**Subject: WATTS BAR NUCLEAR PLANT UNIT 2 - FUEL THERMAL
CONDUCTIVITY DEGRADATION, RESPONSE TO SUPPLEMENTAL
SAFETY EVALUATION REPORT OPEN ITEM 61**

**NON-PROPRIETARY ATTACHMENT TO WESTINGHOUSE LETTER TO TVA WBT-D-4396,
DATED JULY 23, 2013, "THERMAL CONDUCTIVITY DEGRADATION (TCD) EFFECT ON
THE LARGE-BREAK LOCA ANALYSIS FOR WATTS BAR NUCLEAR PLANT UNIT 2"**

ENCLOSURE 4
Tennessee Valley Authority
Watts Bar Nuclear Plant, Unit 2
Docket No. 50-391

Figure 15.4-41a Watts Bar Unit 2 Limiting PCT Case Hotspot PCT At The Limiting Elevation

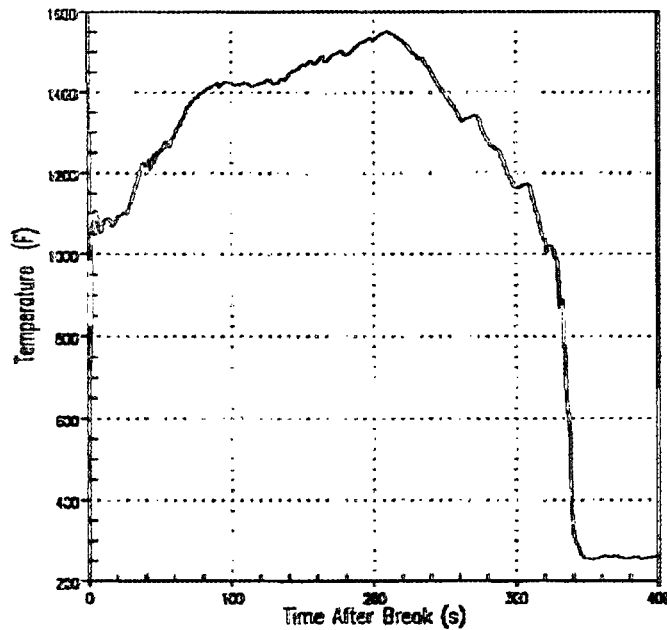
Update per WBT-D-4396 NP - Attachment Figure 1

Figure 15.4-41b - Watts Bar Unit 2 Limiting PCT Case WC/T PCT

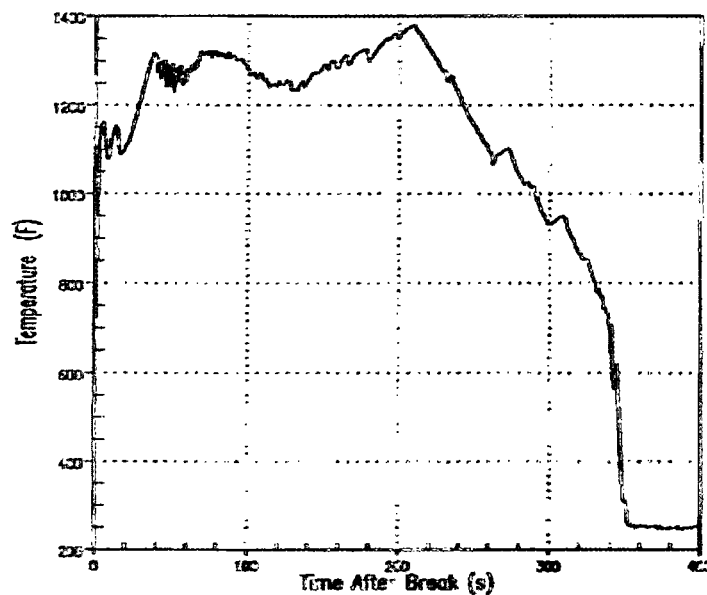
delete this figure

Figure 15.4-44 Watts Bar Unit 2 Limiting PCT Case Broken And Intact Loop Void Fraction

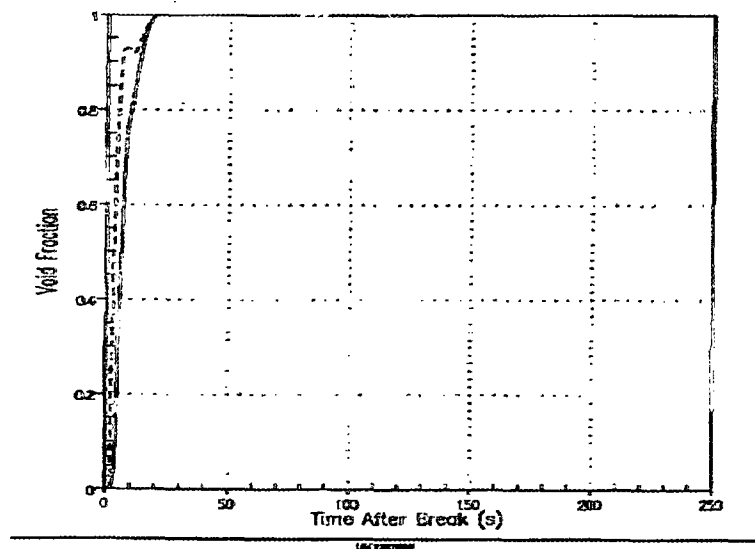
Update per WBT-
D-4396 NP -
Attachment
Figure 4

Figure 15.4-45 Watts Bar Unit 2 Limiting PCT Case Vapor Flow At Top Of Core Average Channel

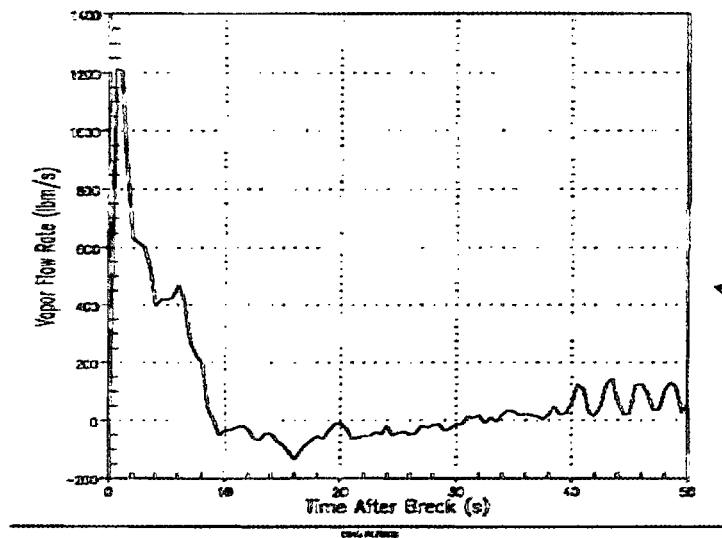
Update per WBT-D-4396 NP - Attachment Figure 5

Figure 15.4-46 Watts Bar Unit 2 Limiting PCT Case Vapor Flow At Top Of Hot Assembly Channel

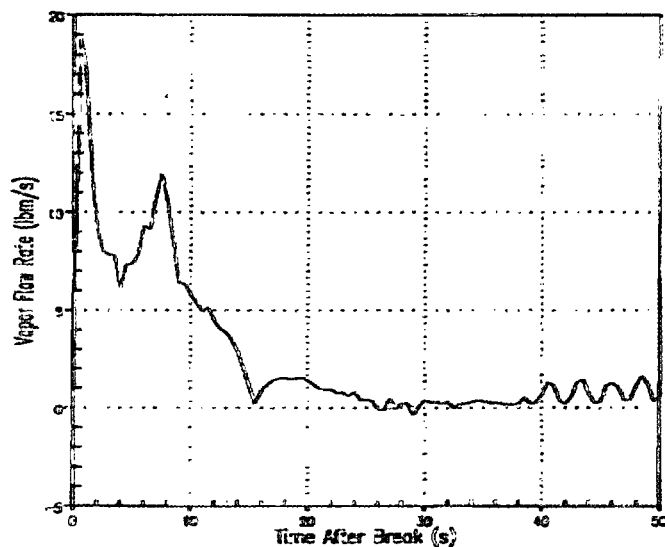
Update per WBT-
D-4396 NP -
Attachment
Figure 6

Figure 15.4-55 Watts Bar Unit 2 Limiting PCT Case PCT For All Rods

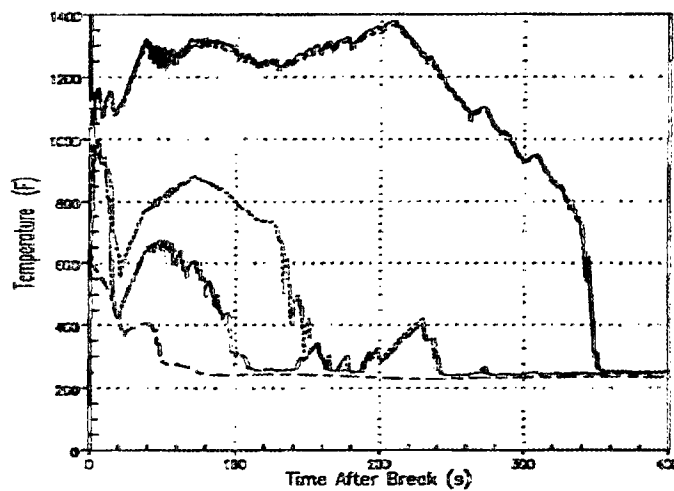
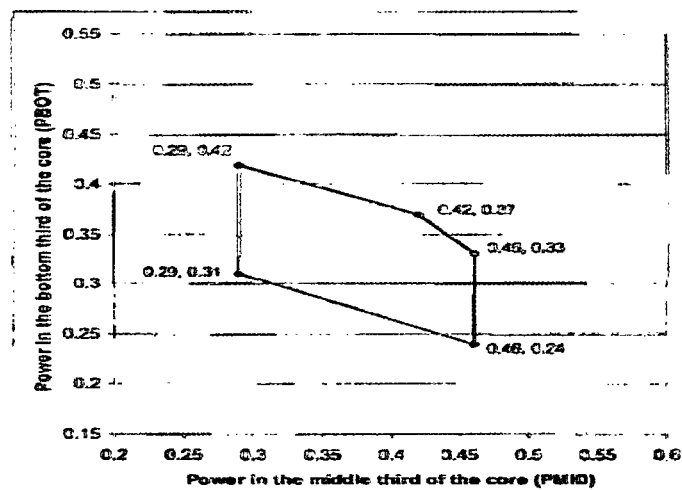
Update per WBT-D-4396 NP - Attachment Figure 15
